WOLF CREEK

November 29, 2005
ET 05-0028

Subject: Docket No. 50-482: 10 CFR 50.55a Request I1R-51 Regarding ASME Section XI Requirements for Examination Coverage of the Reactor Pressure Vessel Nozzle-to-Vessel welds, and Correction to Relief Requests I2R-03 and I2R-21 for WCNOG's Second Inservice Inspection Interval

10 CFR 50.55a Request Number I1R-51

Figure 1

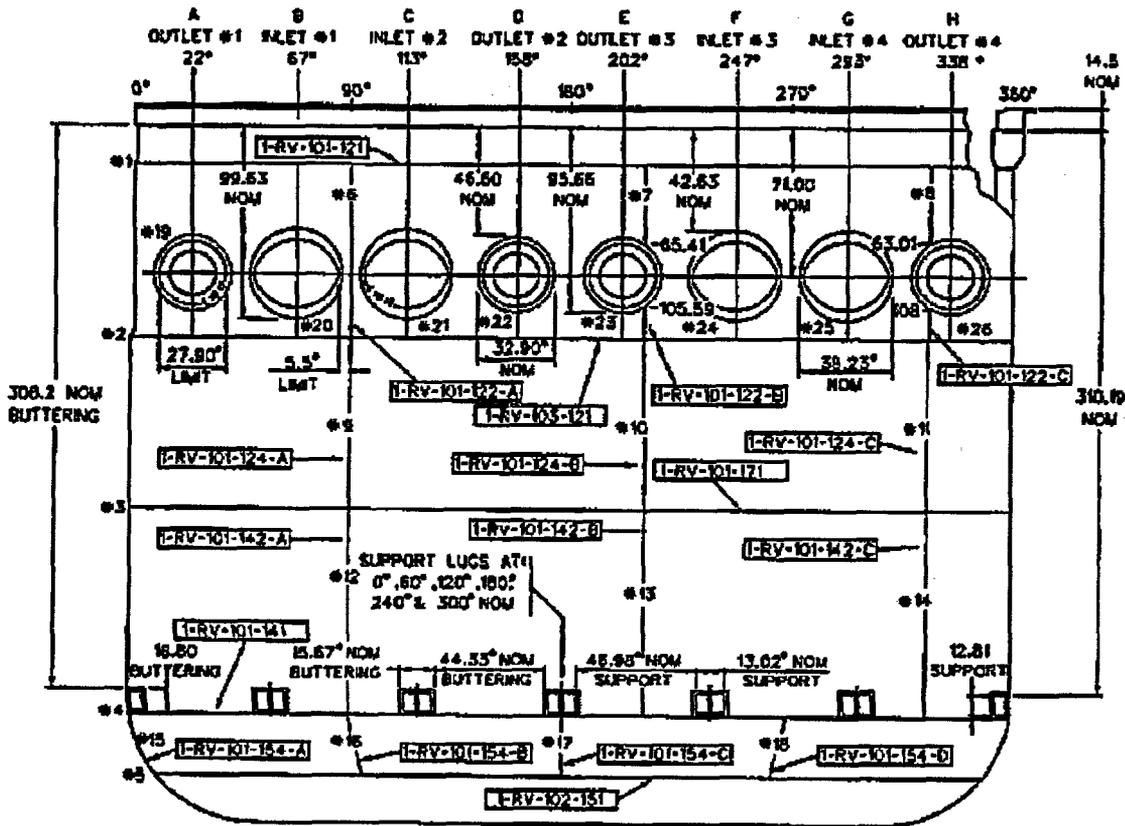
Physical limitations of the UT scans of the Outlet Nozzle to Vessel Welds were due to the outlet nozzle protrusion configurations which prevented full coverage as shown in Figures 1 and 2. Composite coverage of the UT scans was calculated to be 71.5% for each weld. Attachment 1 provides a summary of the inspection coverage.

Examination Limitations: Outlet nozzle protrusions

Composite Coverage: 71.5%

Inspection Volume Coverage Summary: Parallel (2 angles): 43.2%
Perpendicular (2 angles): 99.7%
Zero Degree: 43.2%

The subject welds were examined to the maximum extent possible. An additional 70° angle beam examination was utilized for the near surface (ID) coverage, up to a depth of 1" or 1/4t, whichever is greater.
